23 Ocean Avenue (2016-150) and 1945 Congress (2016-075)

Lets do the 23 Ocean Avenue plan first...

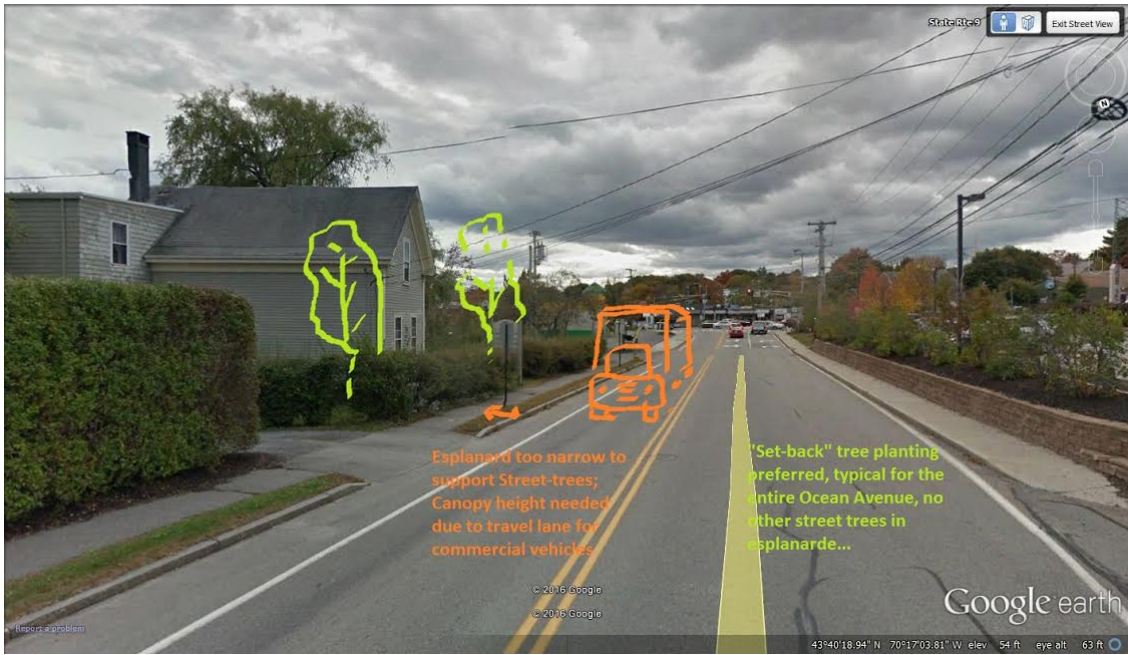
The existing esplanade width is problematic - just too narrow to support Street-trees on both sides, Ocean & Hersey Street. I checked the entire length of Ocean Avenue and no existing street trees, also this is a busy truck / commercial vehicle route and tree canopy even on an upright tree would unlikely to survive. Snow storage in winter along with deicing salts, this sidewalk route is on our priority school walk route and we plow so we need as much space as possible.

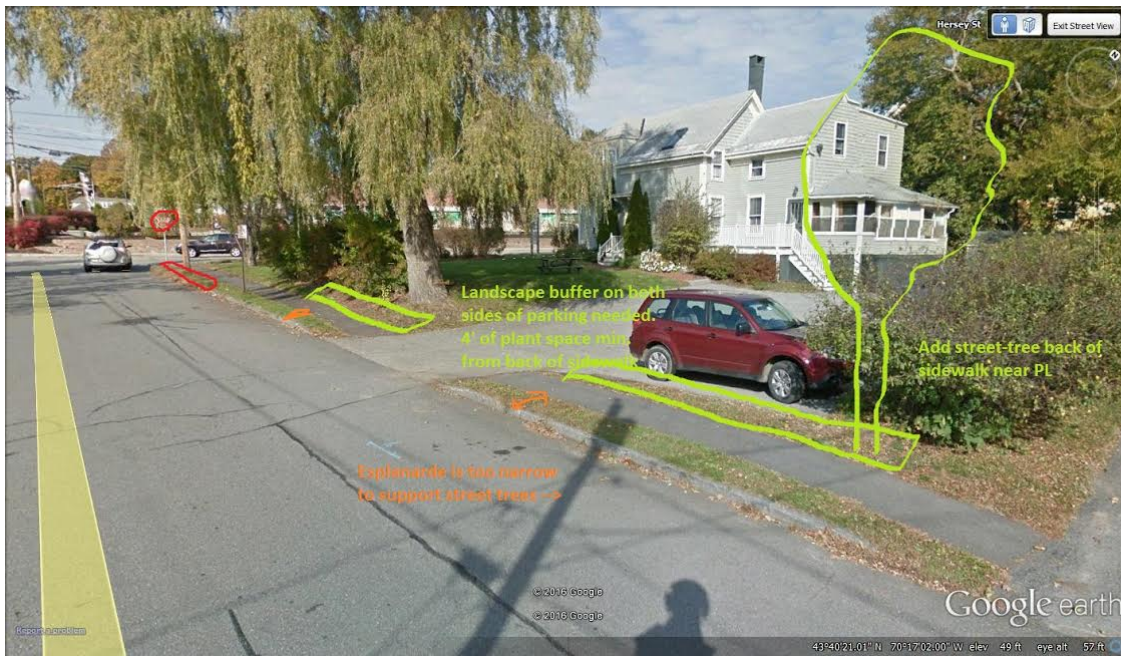
Thus we would like to see 'set-back' tree planting in available spaces. Also parking lot on Hersey Street should have a 4' buffer with plant material at back of sidewalk. A smaller 3' or 2' buffer might not make it. Ideally like to see woody shrub planting but could do ornamental grasses. Wood guardrail on the parking lot side is needed to protect this space from vehicles, snow etc. Without protection plant material would likely be damaged. This buffer on the residential side is more important then the more commerical Ocean Avenue side. Add a couple of trees on the parking lot edge to buffer parking lot from next door residential use. See photos, (I got creative with the pics !)
